BRADLEY HILLS - 5315 GOLDSBORO ROAD NO. 620240130 & F20240640

Administrative Subdivision Plan and Final Forest Conservation Plan to create two lots for a single-family detached unit on each lot.

No. 620240130

Completed:
September 27, 2024

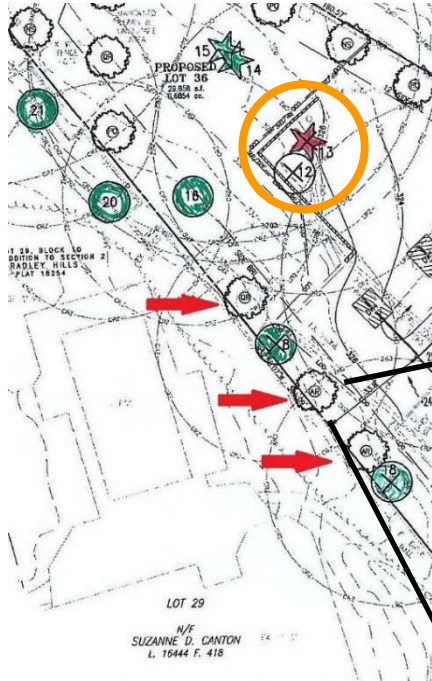
With this in mind, the Forest Conservation Plan (02-FCP-F20240640-004.pdf and related maps) submitted significantly misrepresents the actual property and therefore the Plan. As just one example

(red arrows along left side in plan diagram below), the existing number of trees (approximately 12) is greatly under-represented making it unclear how many and where any “mitigation trees” will go. Moreover, since they are not included, the fate of these existing trees is unclear.

“The Forest Conservation and associated tree save plan variance/mitigation submission has been substantially updated/modified since the initial submission. Additionally, the applicant has obtained the services of an ISA Certified Arborist to prepare the associated tree save plan. Although fine tuning of the plans is still underway,

the overall Forest Conservation/Mitigation is generally in compliance with requirements and can be further discussed/explained in an upcoming meeting with the community."

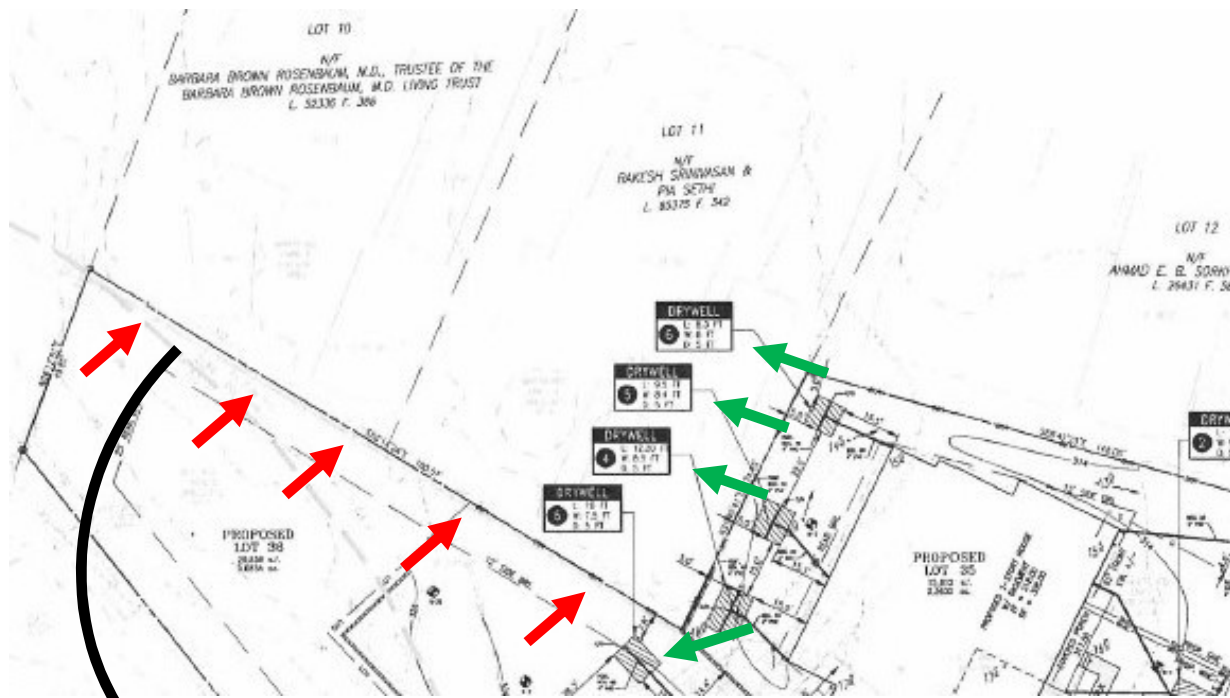
Of particular concern is the upper slope retaining wall of PT 6x6 lumber between Lots 28 and 29.

This wall predates 1990. Areas of end rot are beginning to appear. It is not clear that assessment of water content, rot, wall integrity projection, etc. were undertaken or are planned. These photos show an area of shallow slope. Others not shown are steeper. All this area involves trees listed as “existing”, “mitigation” or as pointed out above, not included in the applicant’s Forest Conservation Plan.

We therefore request that the Planning Department and applicant to **(a)** undertake a complete and comprehensive review of the proposed Development Plan specifically to address the impact of Forest mitigation on this particular sloped area of the lot along its entire length, **(b)**, develop a slope erosion and contour solution that involves removal of all existing retaining structures and detailed plans for their replacement up to and including the most upper retaining wall on the property boundary between Lots 28 and 29, and **(c)** provide a detailed revised plan and written report to this Group regarding the outcomes.

The existing timber wall on Lot 29 is upslope of the subject property and located a considerable distance from the proposed LOD. Therefore, the timber wall will not be impacted by the proposed development and any impacts/renovations of the timber wall are beyond the scope of the project. The existing stone retaining wall which is approximately 4 feet in height and partially in ruins will be completely demolished and replaced with a new wall and/or regrading."

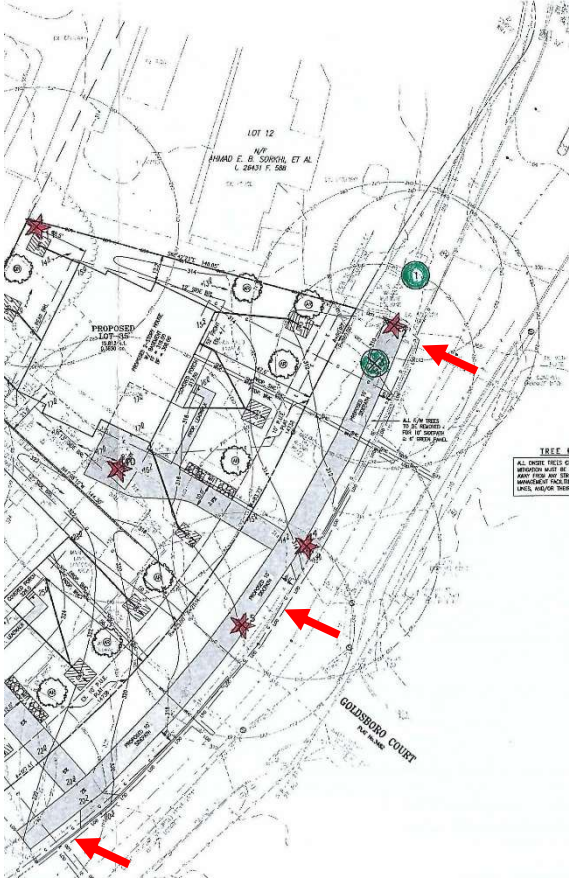
Below: Approximately one-half length view of the stone retaining wall of Lot 11 showing the existing dwelling on the left. Although the immediate slope here appears slight, behind it are the steepest areas of contour leading to the total volume of water runoff directed to this area.

Drywells collect water to later dissipate into the surrounding ground. While this provides collection and deters surface flooding, it does not solve the later ground saturation that, through pressure, will still impact this retaining wall. And with high rain volumes, the potential for drywell overflow still exists.

We request a wholistic water drainage system be put in place along the property boundary line of Lots 10 and 11. **For clarity, the property owners of these lots are not asking for the stone wall to be replaced.** We feel that a properly placed system that collects and diverts water completely away from these properties is required. Examples could include but not be limited to a series of connected collection wells, French drains, open collectors, or other combinations of engineering solutions.

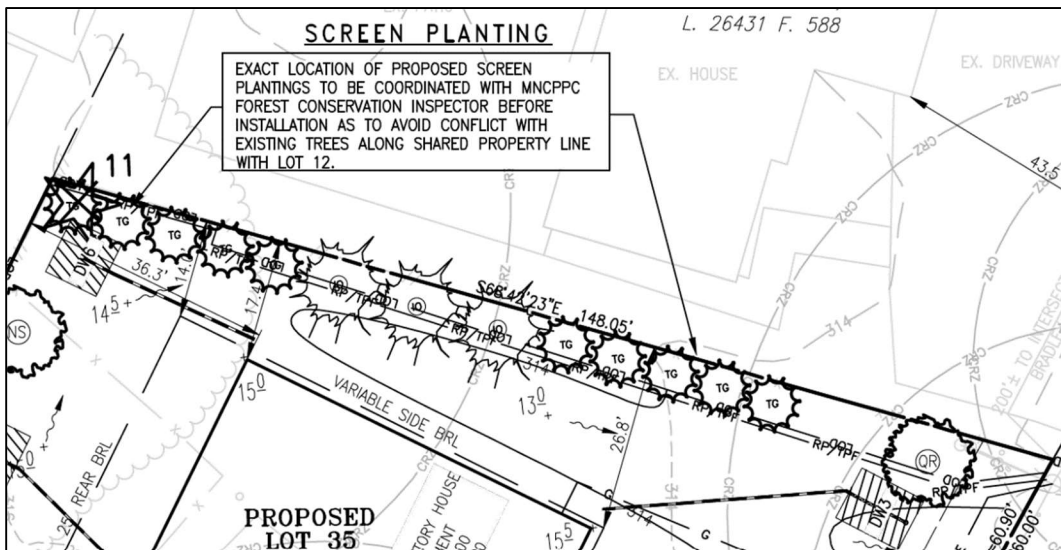
Clarity and additional solutions are required regarding trees (TG) between Proposed Lot 35 (PL35) and Lot 12. This boundary consists of a black chain link fence approximately 4' in height and following westward into an old wooden fence in disrepair.

The revised FCP indicates that 12 "screen plantings" are proposed of types TG and IO. As the legend notes, exact placement is to "avoid conflict with existing trees" based upon coordination with an MNCPPC inspector.

Any proposed solution to the removal of existing foliage along this border must include specific discussion with the residents of Lot 12 as to whether retention or complete removal and replanting is preferred.

GRG feels these screen plantings could be a solution if in addition, a replacement fence of no less than 6' in height is installed along the entire boundary to Lot 12. CPJ must recognize the complete loss of privacy that currently exists under the present lot and single home, proposed to be interrupted by a 2-story structure less than 20 feet from the boundary between PL35 and Lot 12.
